Addendum No. 2

Macon-Bibb County Middle Georgia Regional Airport

RUNWAY 5-23 EXTENSION – PHASE 1, RETAINING WALL STRUCTURE – PHASE 1

Passero Associates, LLC
4730 Casa Cola Way, Suite 200
St. Augustine, FL 32095
PA Project No. 20070044.0023

Drawing No.
C1-1

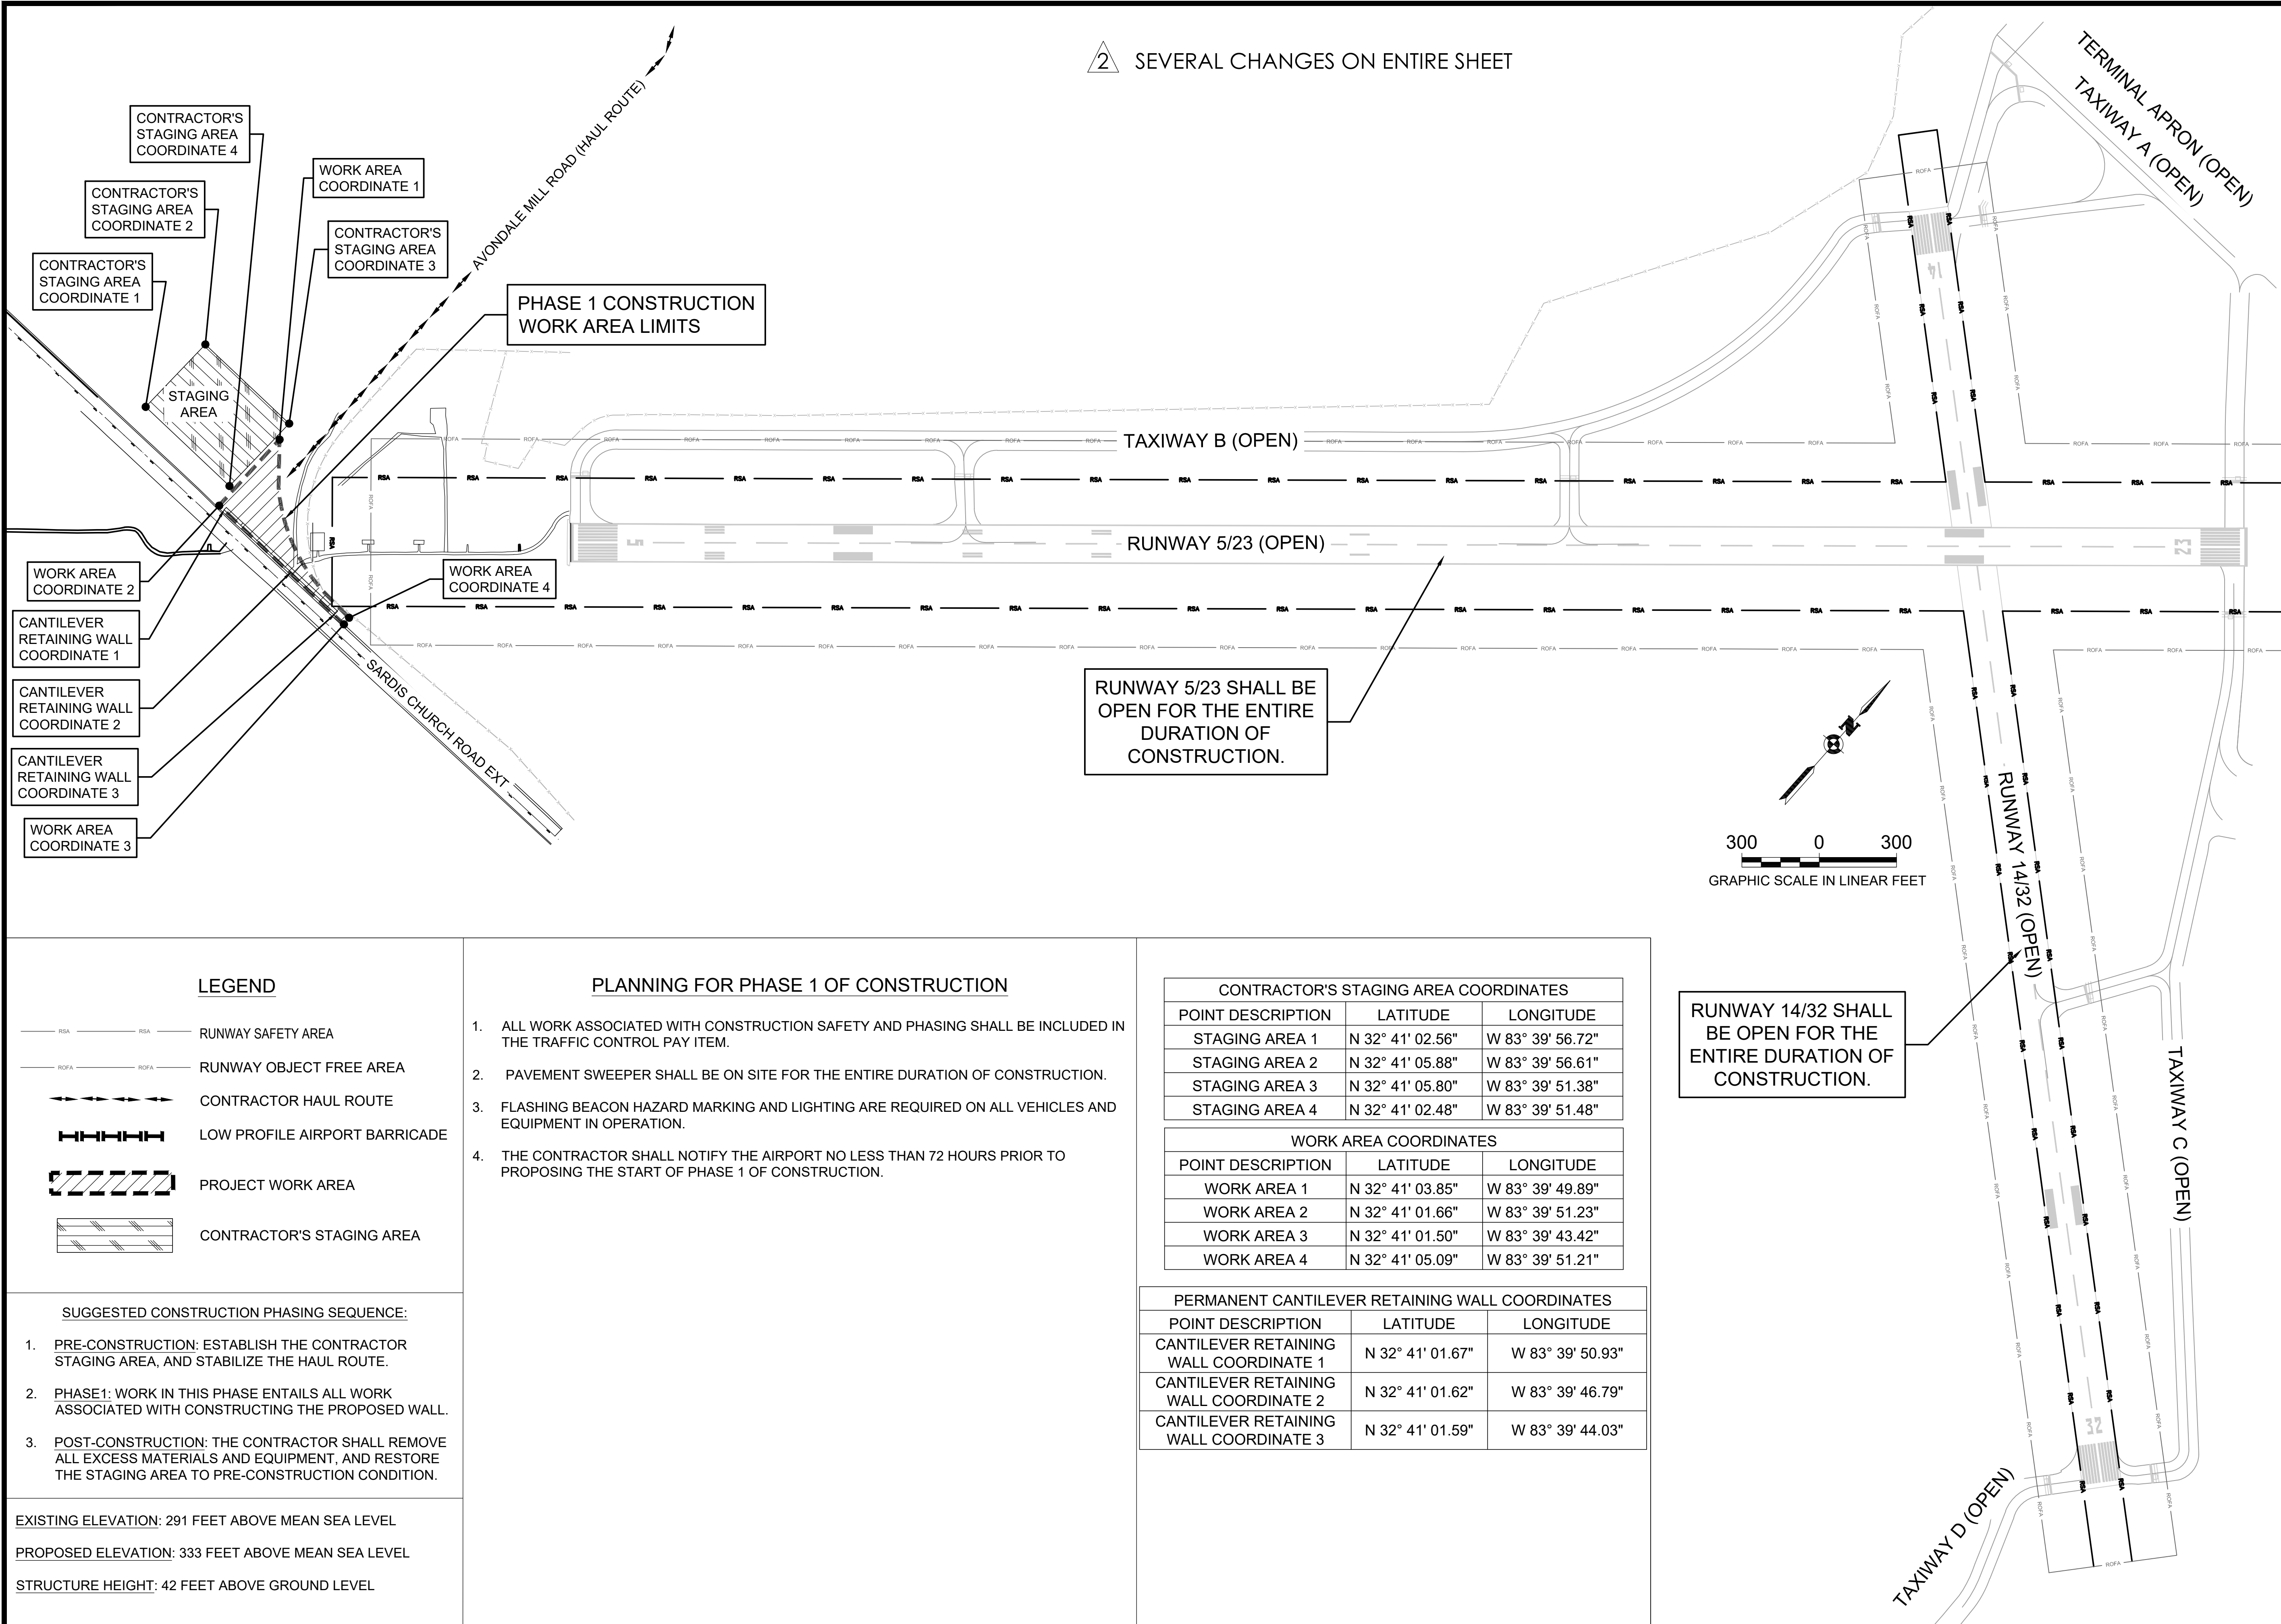
1. **REVISED** Bid Quantities added to **Sheet G1-2.**
2. **REVISED** Notes on **Sheet G1-3.**
3. **REVISED** Notes on **Sheet C1-1.**
4. **REVISED** **Sheet C1-2.**
5. **DELETE** **Sheet C1-3.**
6. **REVISED** **Sheet 32-0002.**

2 SEVERAL CHANGES ON ENTIRE SHEET

NOT IN CONTRACT ← → **BEGIN WALL CONSTRUCTION STA. 398+30.00**

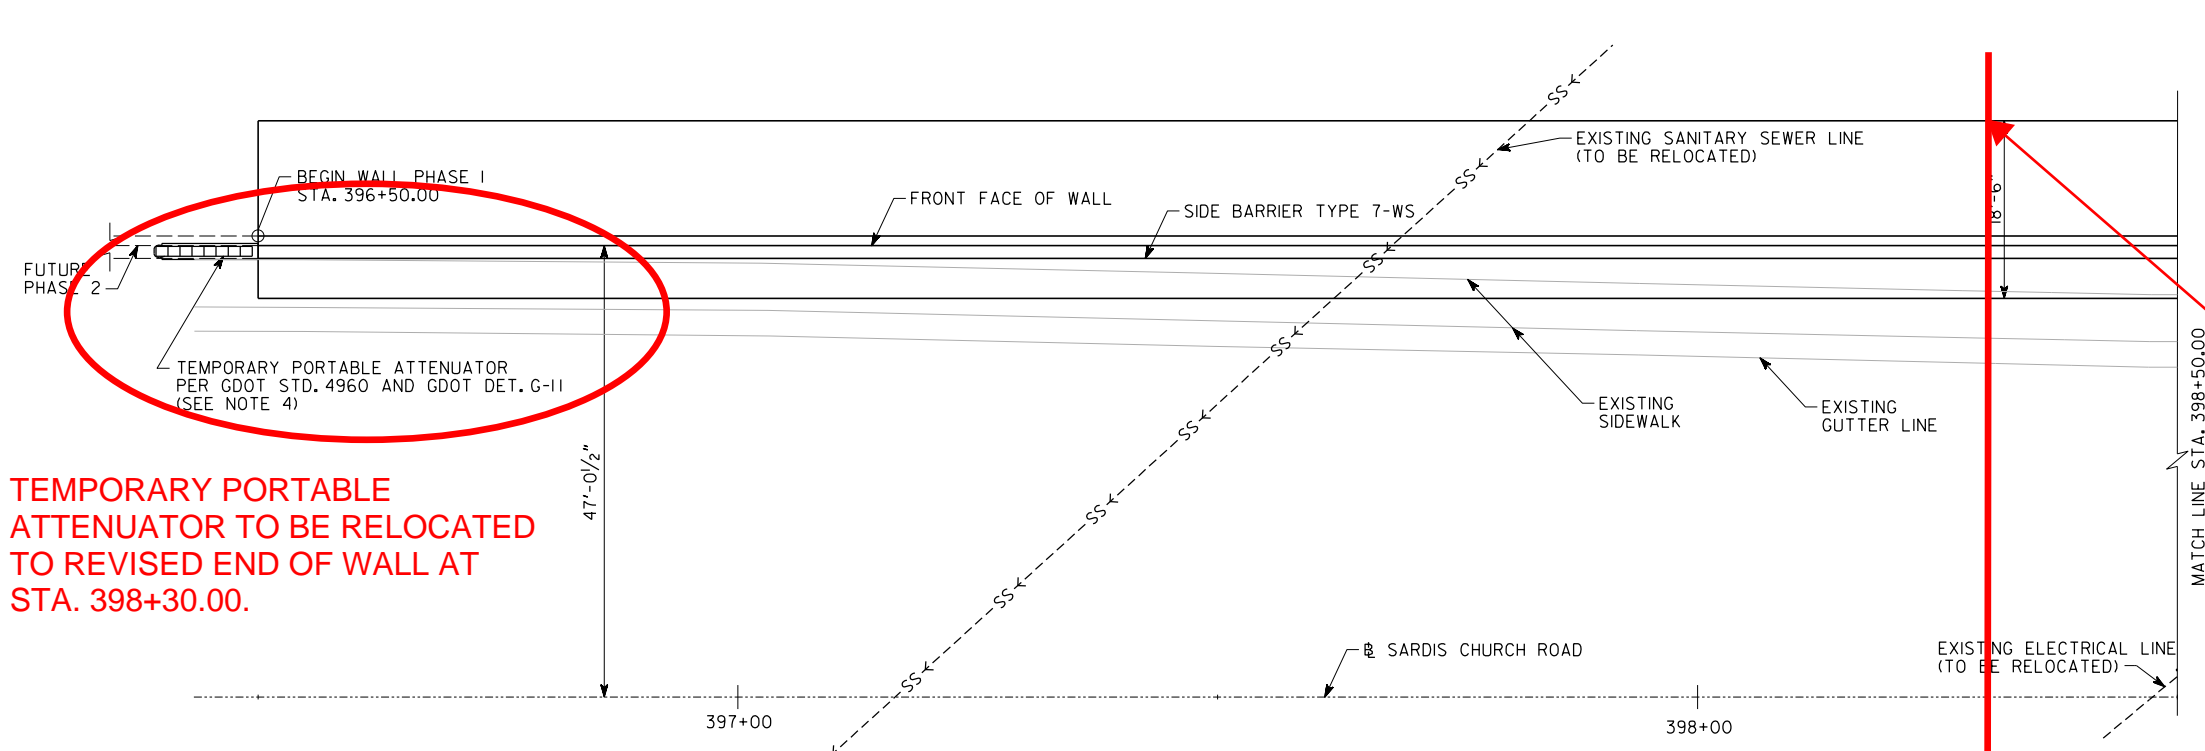
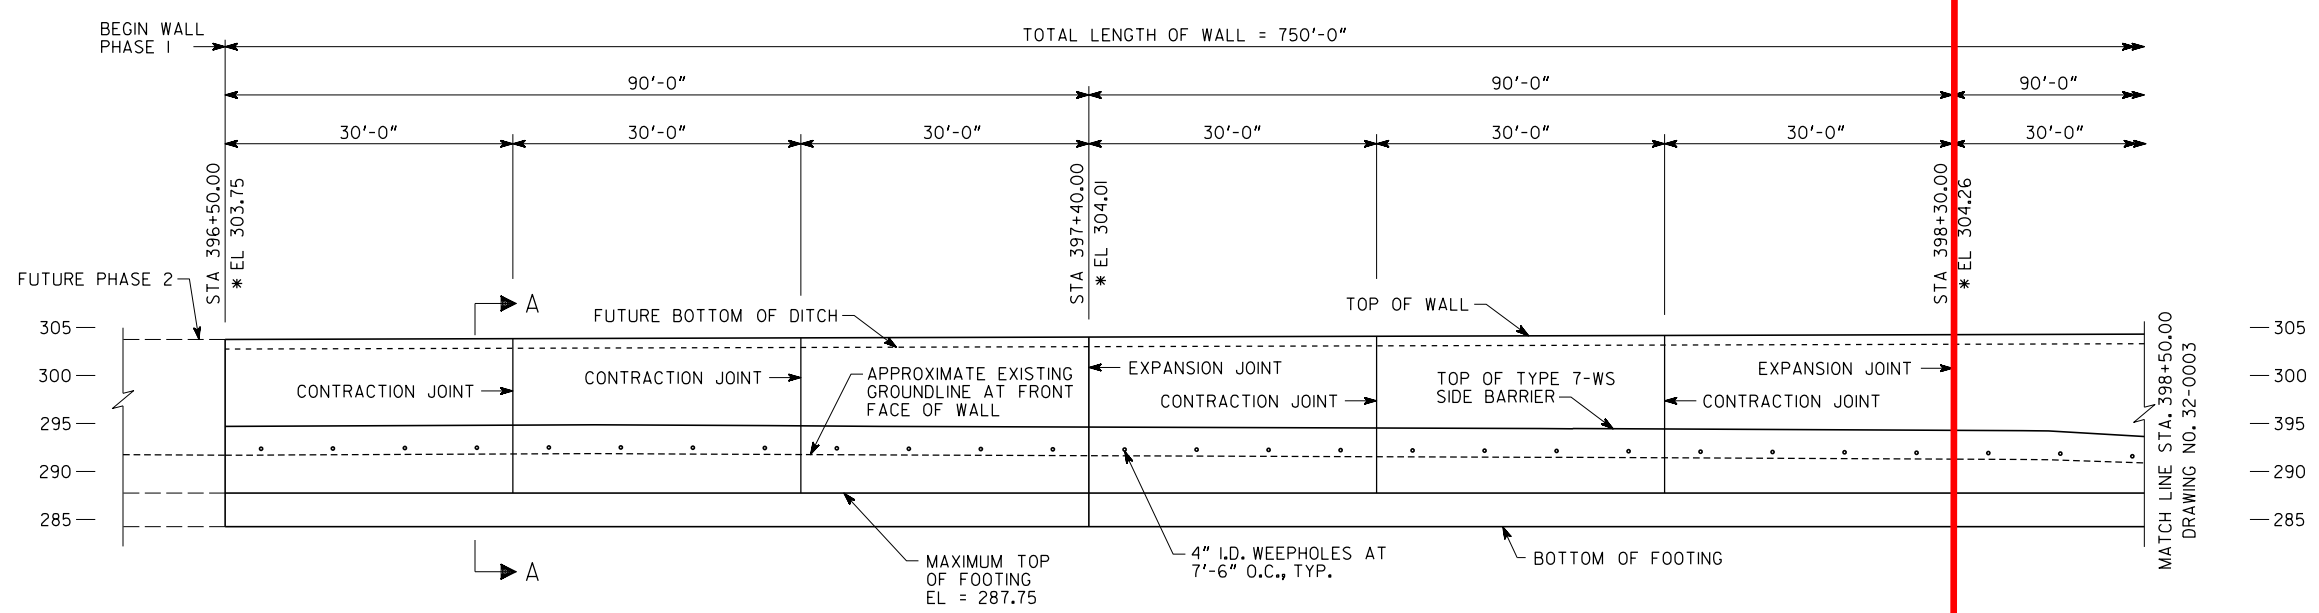
TEMPORARY PORTABLE ATTENUATOR TO BE RELOCATED TO REVISED END OF WALL AT STA. 398+30.00.

DRAWING NO.
32-0005

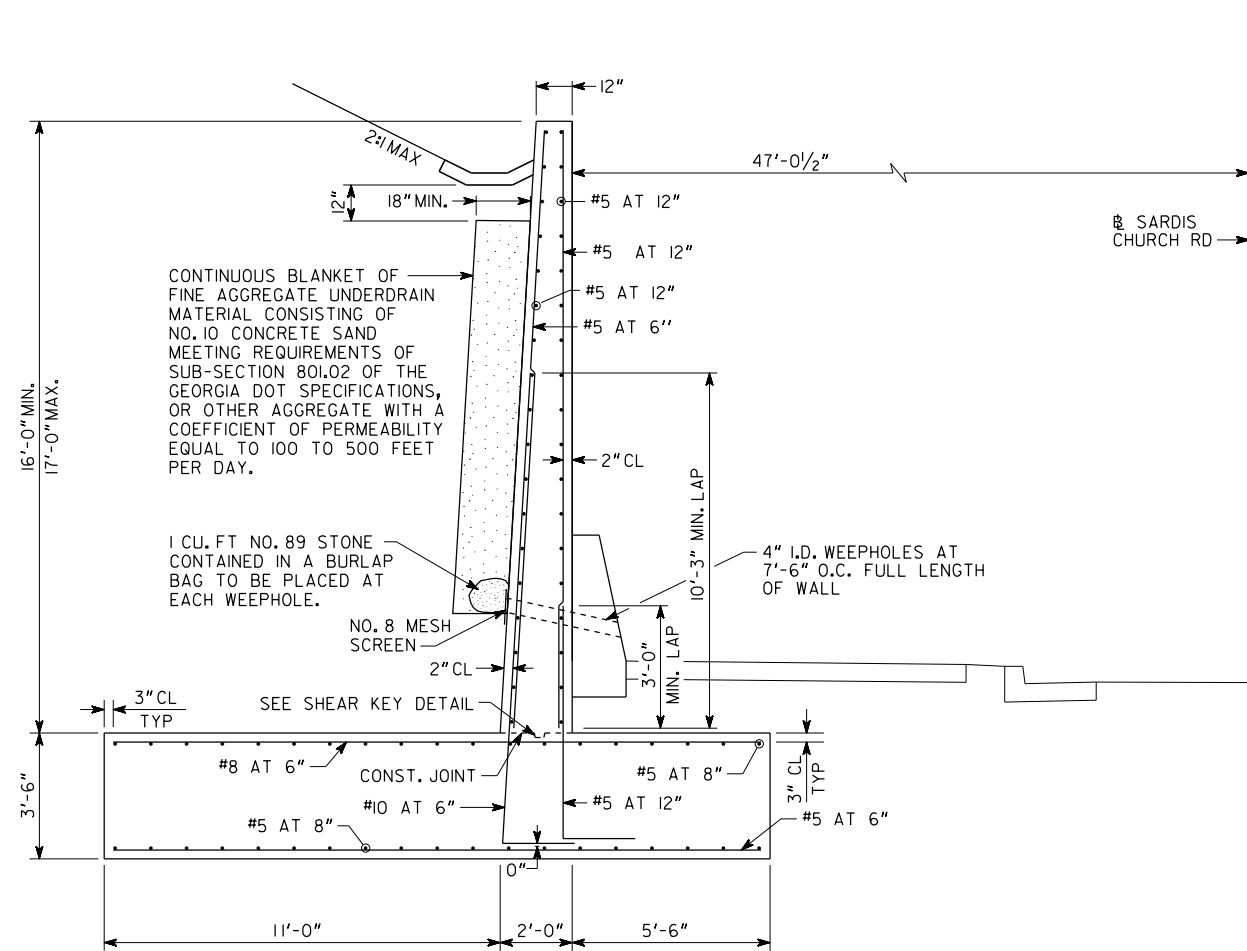
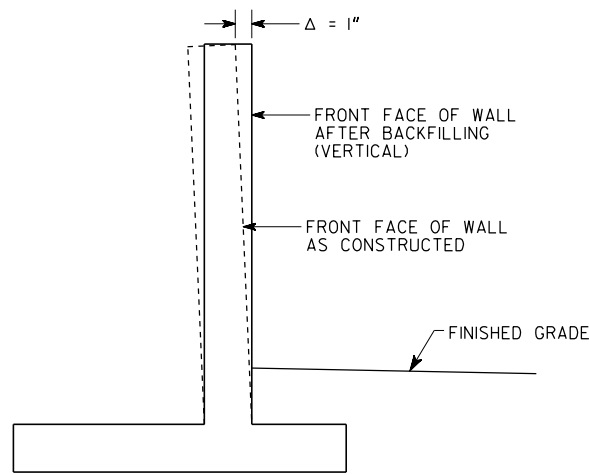
3. *Based on Dwg. No. 32-0005 (Section A-A) the edge of footing on the front face of the wall will be in close proximity to the existing storm drain running parallel to the wall. In order to evaluate possible shoring considerations, please provide the diameter of the storm drain and its location relative to the proposed footing to include elevation.*

4. *Based on Dwg. No. 32-0005 (Section A-A) it appears the existing sidewalk will need to be removed in order to install the proposed footing. Please advise if the sidewalk will need to replace in-kind, and if so, please provide a detail of the required new sidewalk.*

The storm line in question is an 18" diameter concrete pipe. Elevation data was not collected as a part of the survey phase of the project.

A line item has been included in the bid for sidewalk replacement.
